Item Name: Crosstube Turning Detail

DART AEROSPACE LTD		Work Order:	112780
Description: Crosstube Assembly (205/212 High Aft)		Part Number:	D212-664-241
Inspection Dwg: D212-664-241 Rev: D		Page 1 of 2

DRAWING NO. D212-664-241	TITLE CROSSTUBE ASSY (205/212 HI AFT)	REV. D	DART AEROSPACE LTD ENGINEERING ORDER		D.E.O. NO. D212-664-241-D-1	SHEET NO. SHEET 1 OF 2	SCALE NTS
DRAWN	CHECKED	MFG. APPR.	APPROVED	DE APPR.			
DATE 11.04.07	DATE 11.04.11	DATE 11.04.12	DATE 11/04/12	DATE 11.04.12

DRAWING NO. D212-664-241	TITLE CROSSTUBE ASS'Y (205/212 HI AFT)	REV. D	DART AEROSPACE LTD ENGINEERING ORDER		D.E.O. NO. D212-664-241-D-2	SHEET NO. SHEET 1 OF 1	SCALE NTS
DRAWN <i>q</i>	CHECKED <i>ASS</i>	MFG. APPR. <i>SS</i>	APPROVED <i>MD</i>		DE APPR. <i>MD</i>		
DATE 11.07.15	DATE 11.07.20	DATE 11.07.21	DATE 11.07.21		DATE 11.07.21

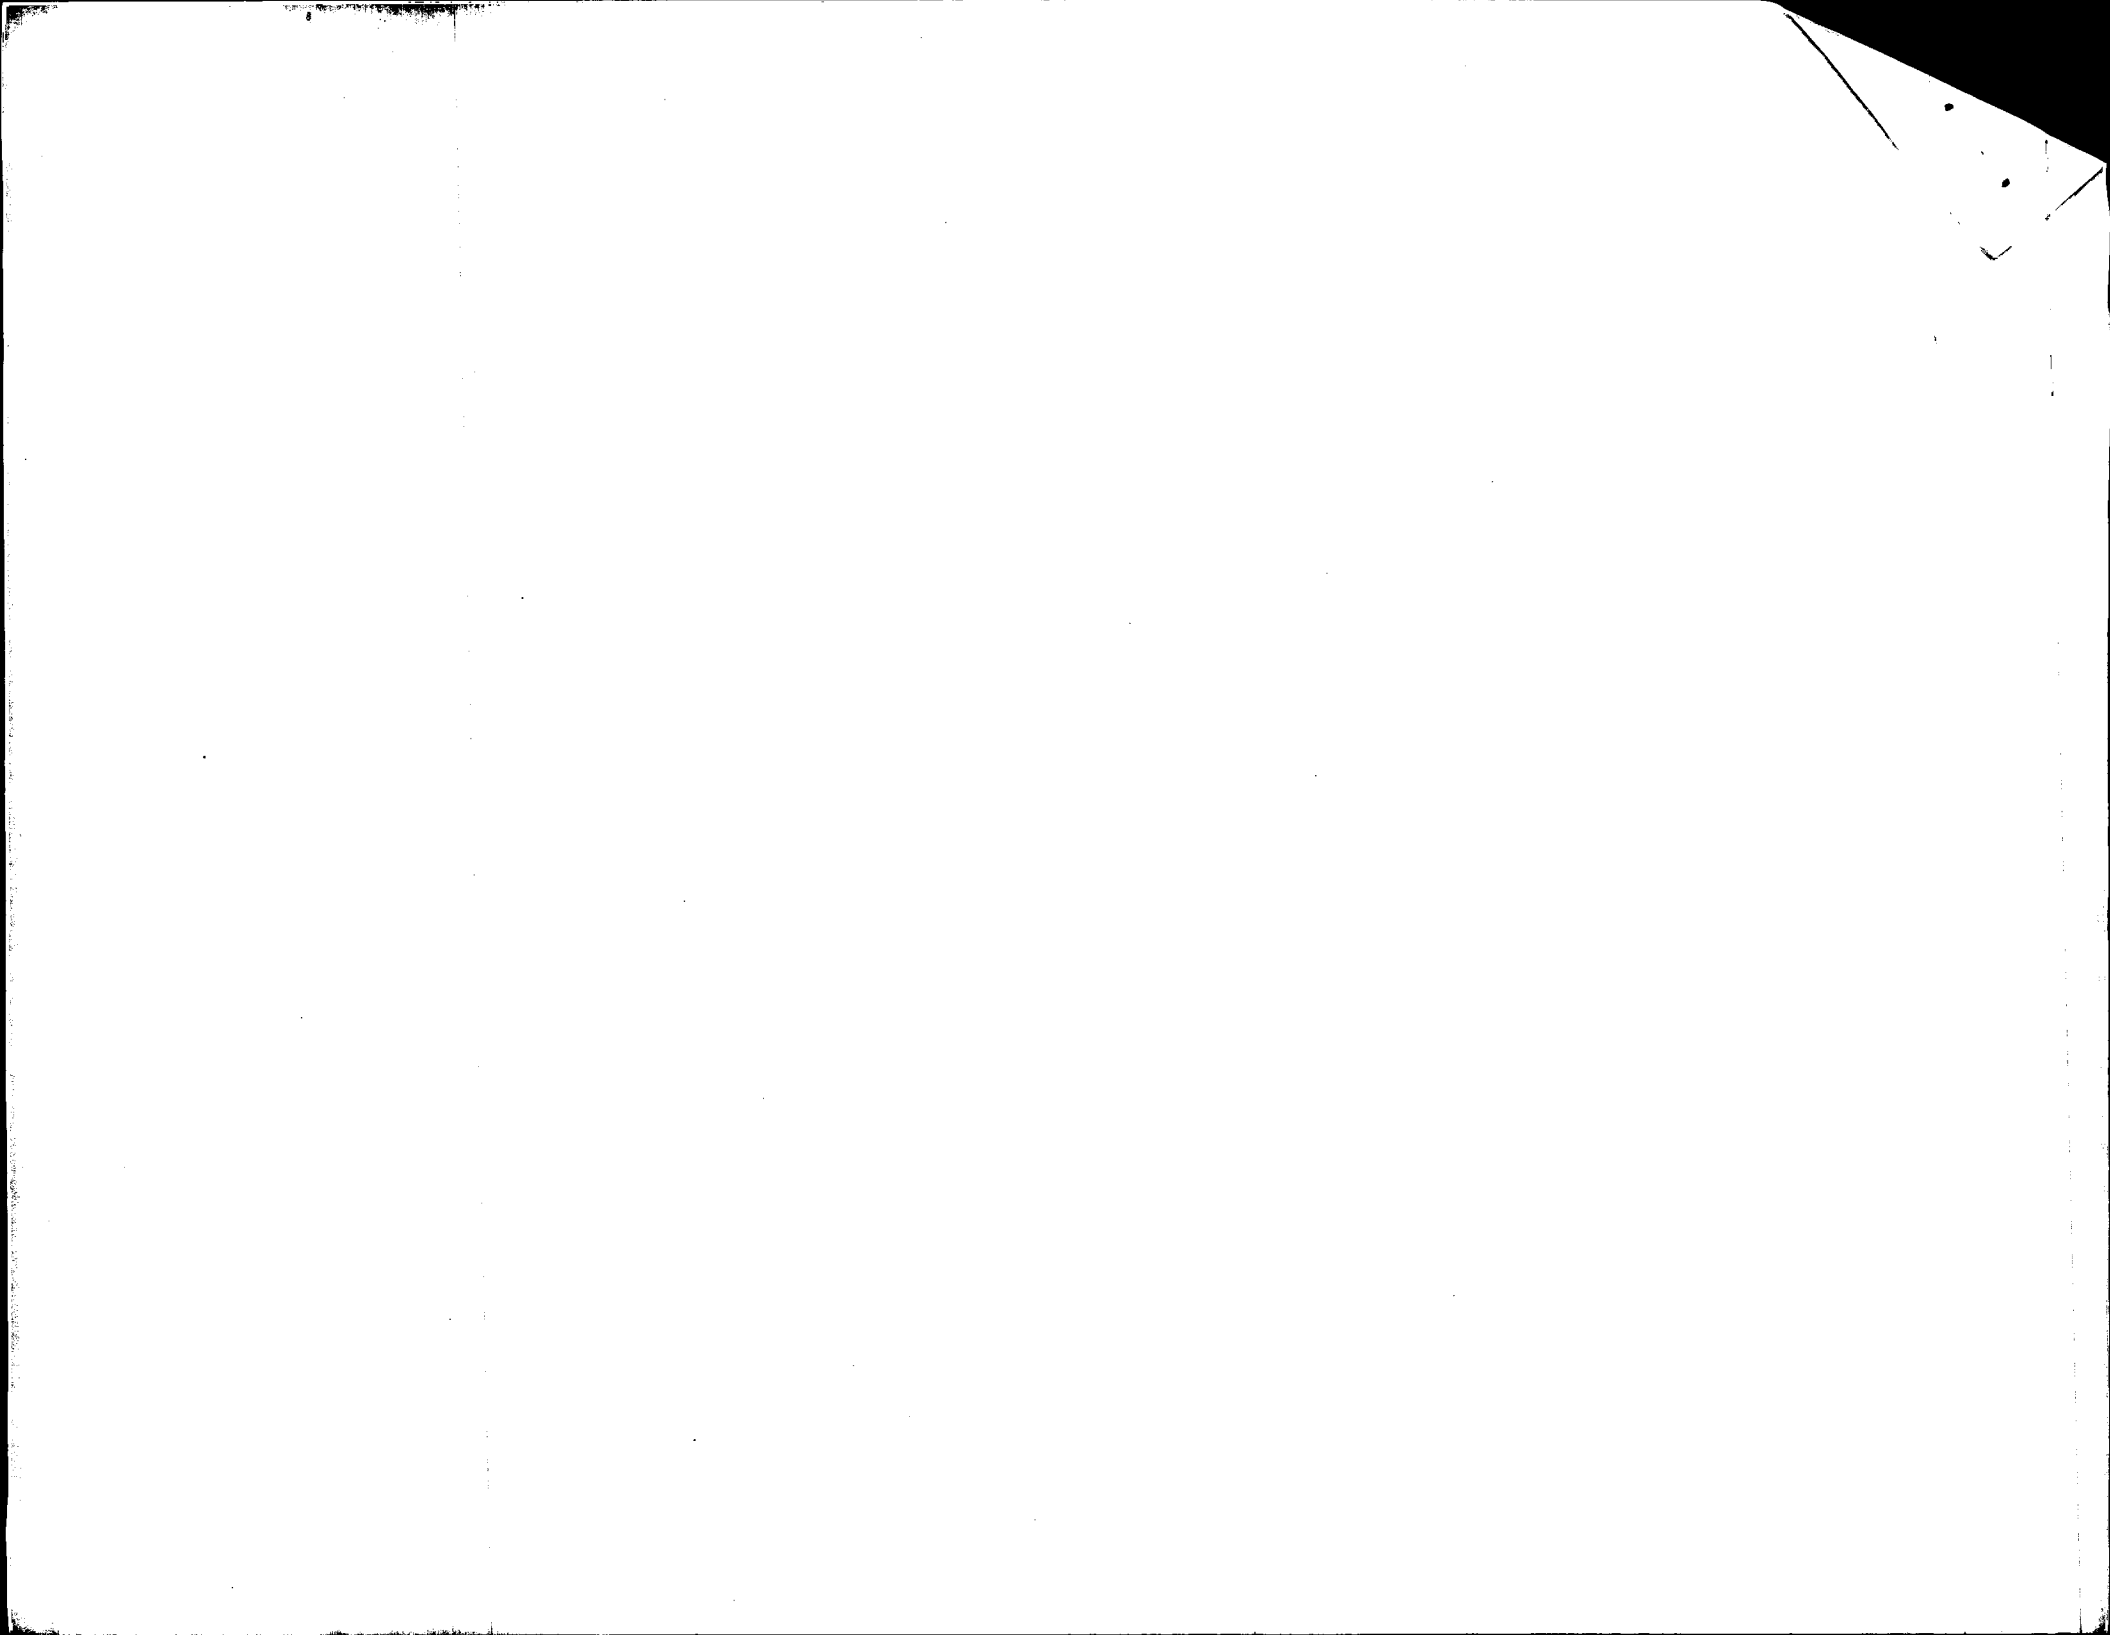
ADD AN INSPECTION WINDOW TO UNDERSIDE OF CROSSTUBE.

NOTES 2 OF SHEET 1 IS AMENDED AS FOLLOWS:

IS:

WAS:

- 2) FINISH: CHEMICAL CONVERSION COAT PER DART QSI 005 4.1
PRIME INSIDE AND OUTSIDE PER DART QSI 005 4.2
PAINT OUTSIDE PER DART QSI 005 4.2

- 2) FINISH: CHEMICAL CONVERSION COAT PER DART QSI 005 4.1
PRIME INSIDE AND OUTSIDE PER DART QSI 005 4.2
MASK UNDERSIDE OF CROSSTUBE AS SHOWN (HATCHED AREA) AND
PAINT OUTSIDE PER DART QSI 005 4.2
REMOVE MASKING AND APPLY CLEAR COAT

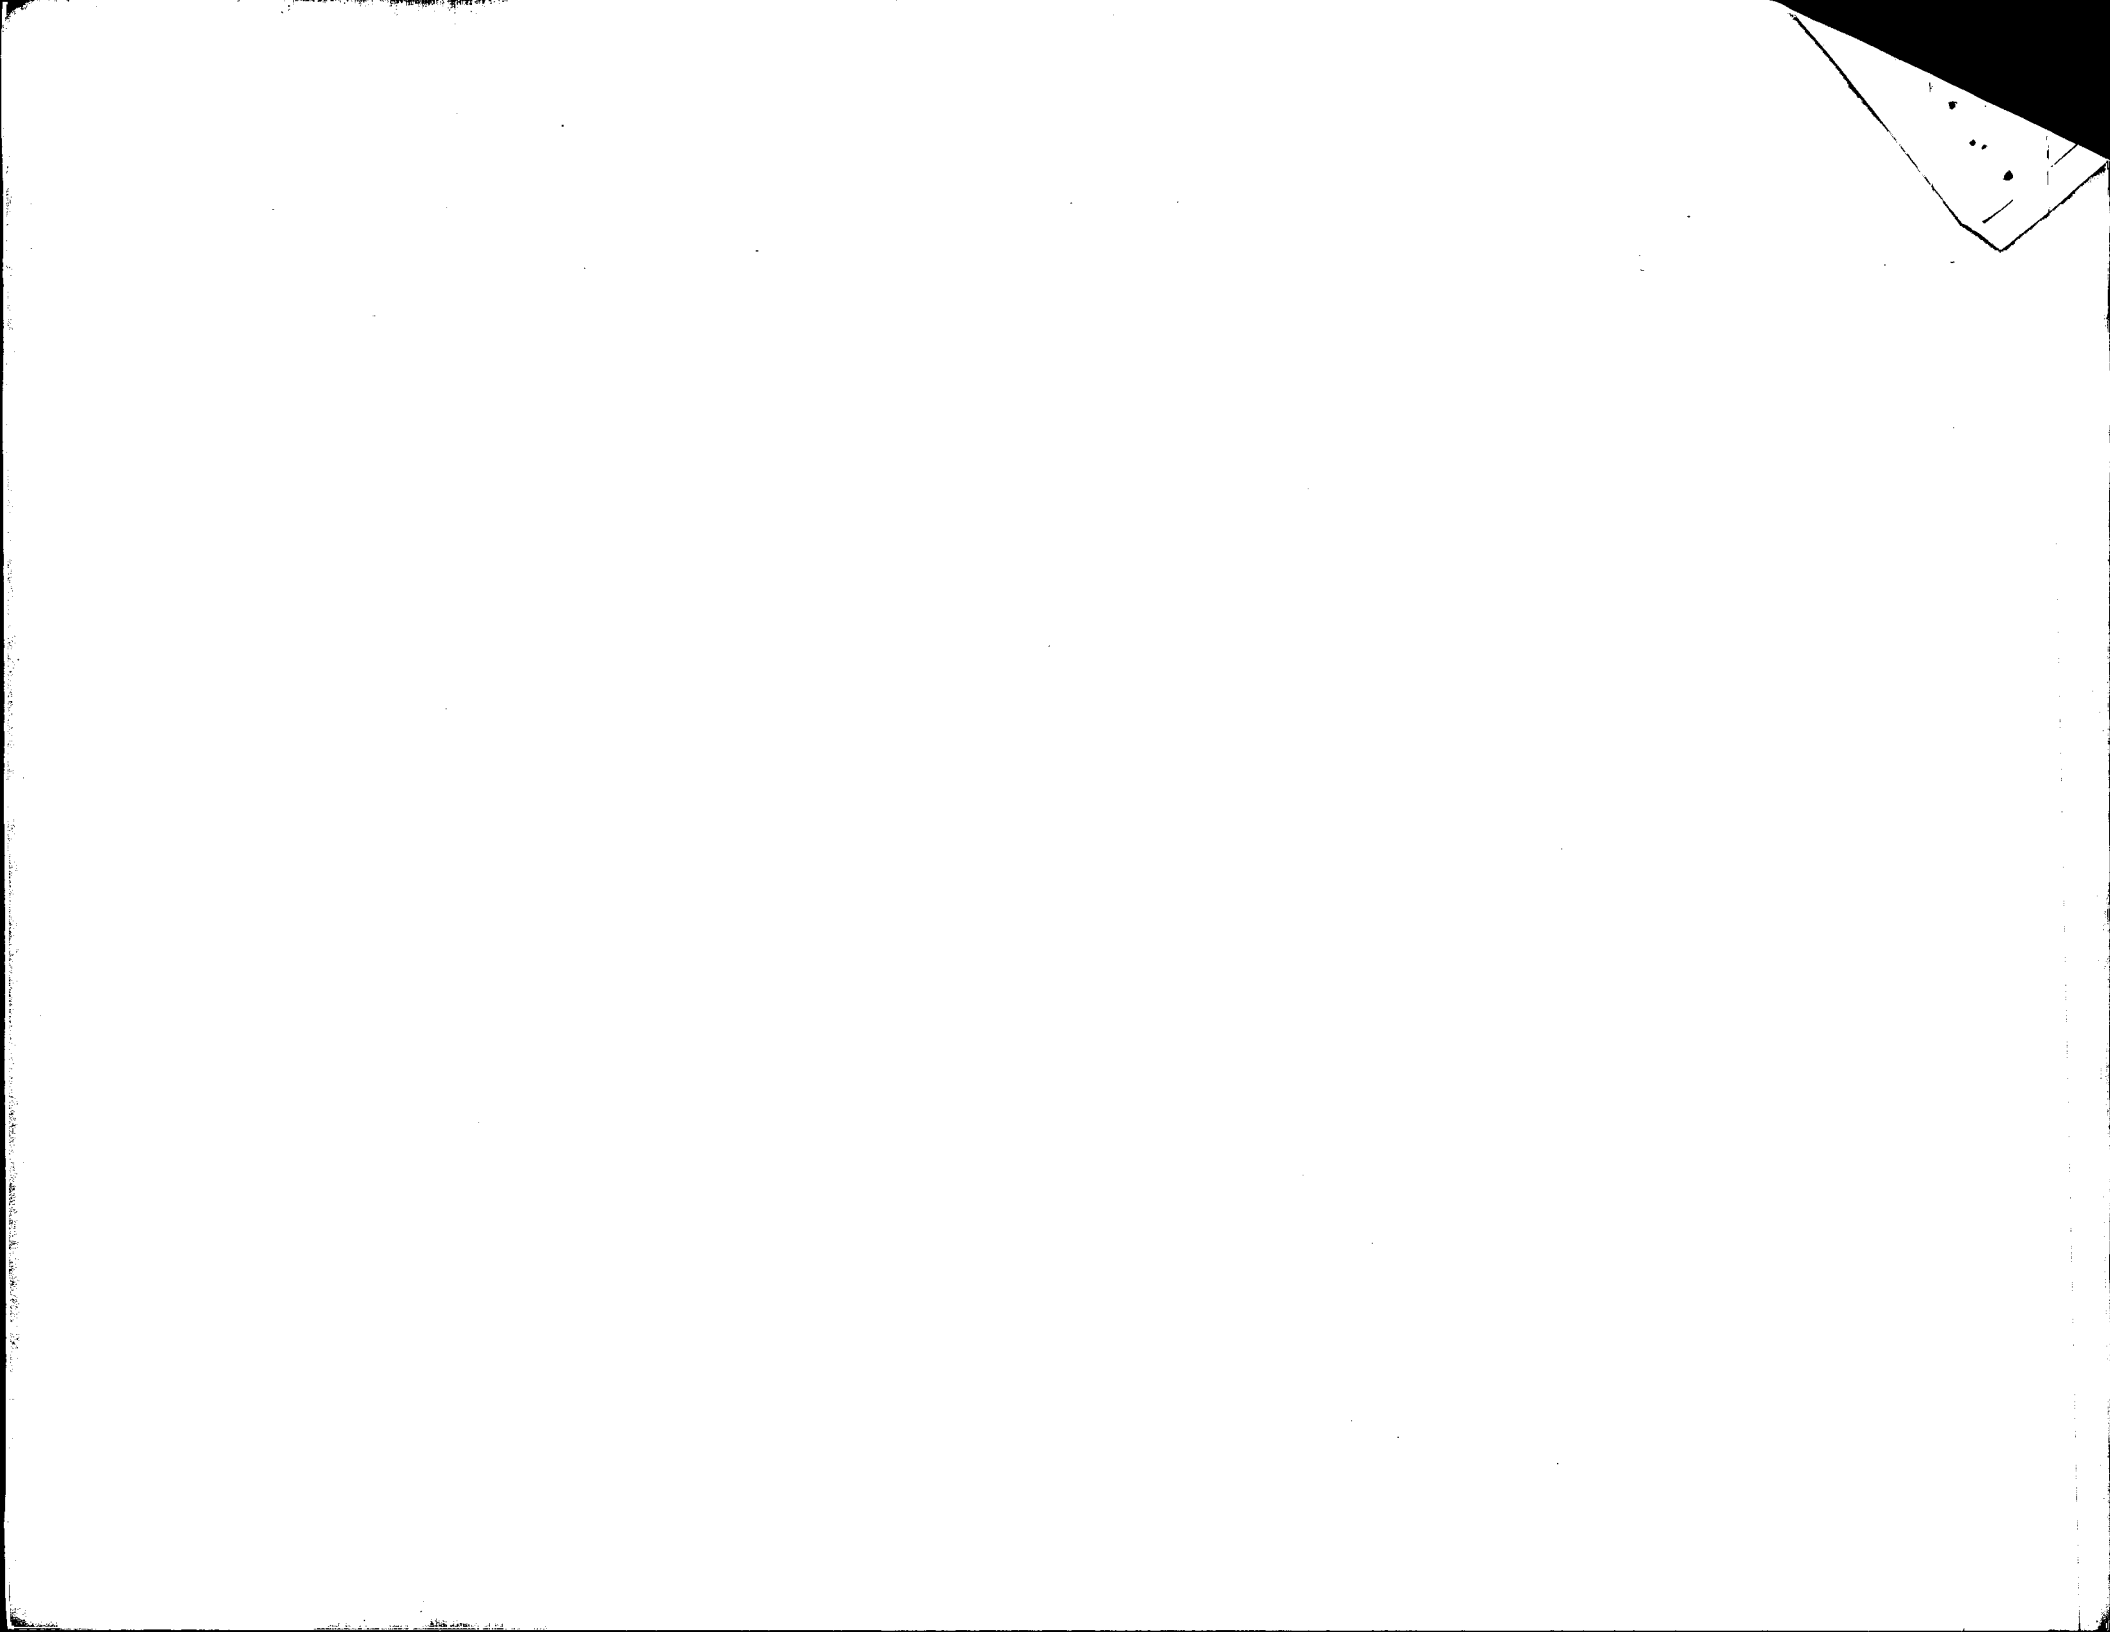
PURPOSE:

IS:

WAS:

MASK AREA PRIOR TO PAINTING,
REMOVE MASKING AFTER PAINT
AND APPLY CLEAR COAT

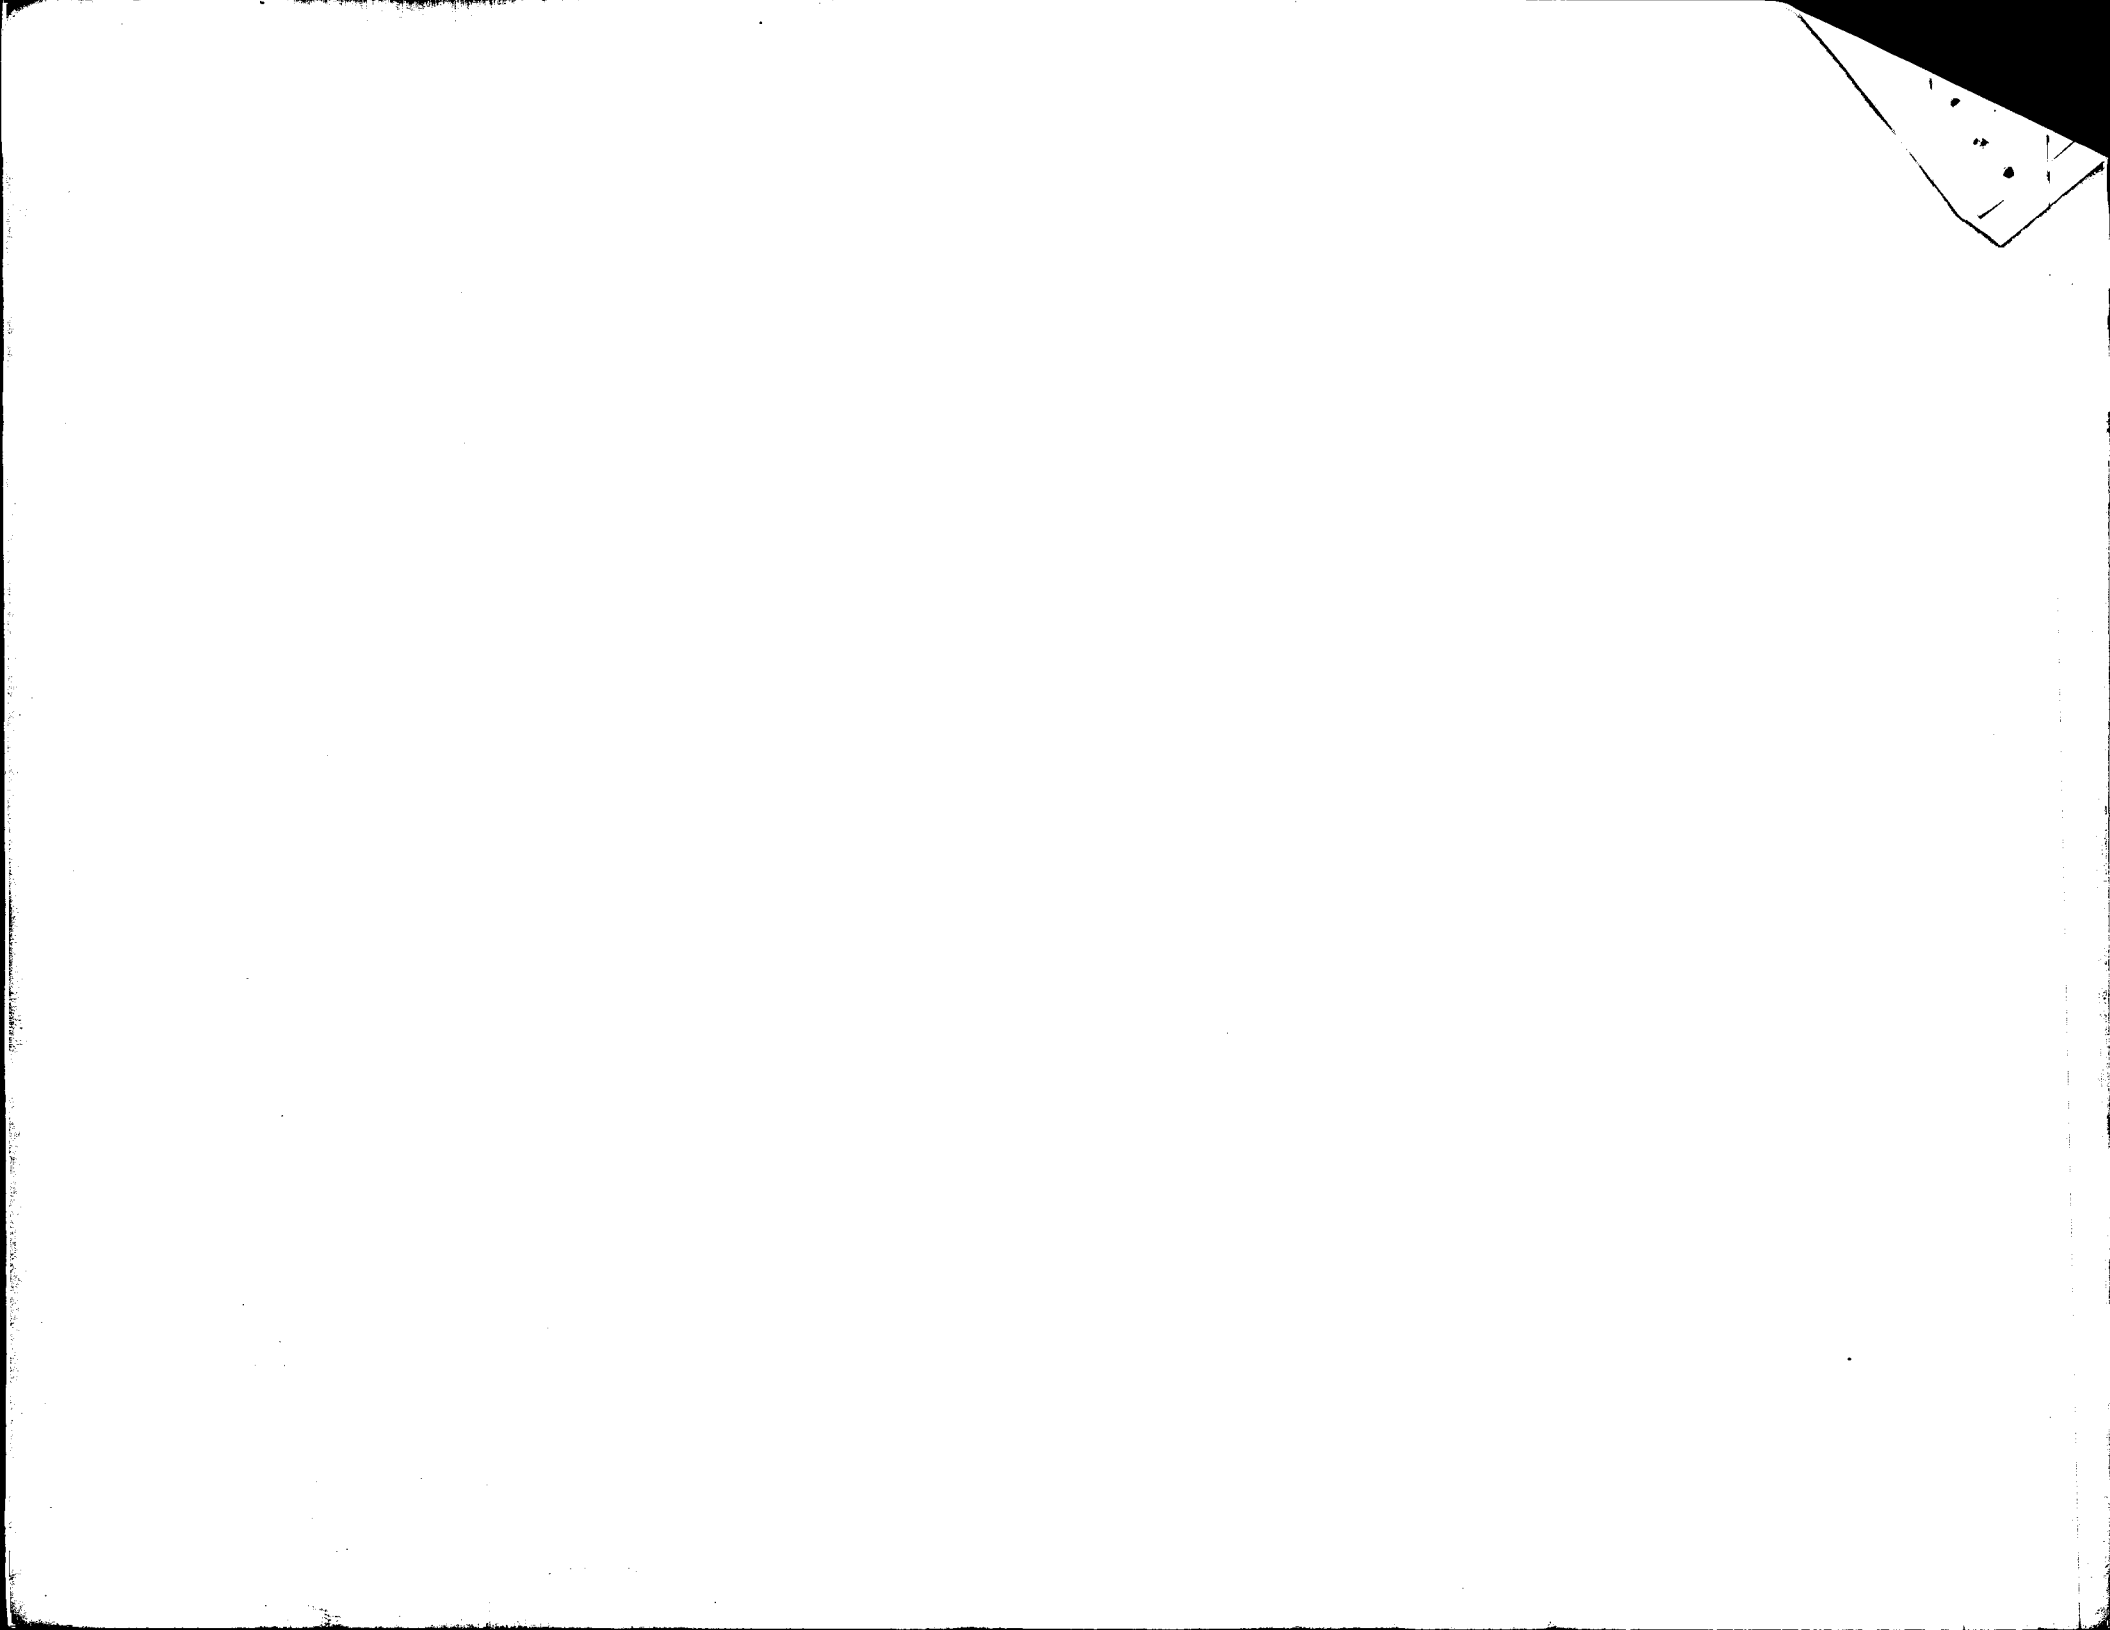
PURPOSE:

REPLACE MAGNOBOND WITH PROSEAL.

WAS:

7	A/R	A/R	MAGNOBOND 6398	ROCKWELL SPECIFICATION RBO-120-023 ADHESIVE (TEXTRON/BELL SPEC. 299-947-100, TYPE II, CLASS 2 ADHESIVE)
---	-----	-----	----------------	---

WAS:

- 12) INSTALL D2940-1 SUPPORT USING 0.03" TO 0.06" THICK LAYER OF MAGNOBOND 6398 TO THE SURFACE OF D2940-1 THAT WILL BE IN CONTACT WITH THE CROSSTUBE PER QSI 015. LET CURE FOR 12 HOURS AFTER INSTALLATION AND PRIOR TO PACKAGING.
- 15) TORQUE CLAMPS 80 TO 100 IN-LB. ENSURE AT LEAST 1.5 THREADS SHOWING IN SAFETY AND THAT NUT HAS NOT BOTTOMED-OUT AFTER TORQUING.

IS:

Item	Qty -241	Qty -241B	Part Number	Description
7	A/R	A/R	PROSEAL 890 B-2	SEALANT, AMS-S-8802 CLASS B-2

NOTE 12 & 15, SHEET 1 IS AMENDED AS FOLLOWS:

IS:

- 12) TO INSTALL D2940-1 SUPPORT: ABRASE MATING SURFACE OF SUPPORT AND CROSSTUBE WITH 180-GRIT SANDPAPER AND REMOVE RESIDUE WITH MEK (OR EQUIVALENT). APPLY A 0.04" TO 0.07" THICK LAYER OF PROSEAL 890 CLASS B-2 (OR AMS-S-8802 CLASS B-2) SEALANT TO MATING SURFACE OF SUPPORT.
- 15) TORQUE CLAMPS 80 TO 100 IN-LB. ENSURE AT LEAST 1.5 THREADS SHOWING IN SAFETY AND THAT NUT HAS NOT BOTTOMED-OUT AFTER TORQUING. **PRIOR TO PACKAGING, RE-CHECK TORQUE ON CLAMPS AFTER PROSEAL 890 SEALANT HAS CURED FOR 72 HOURS.**
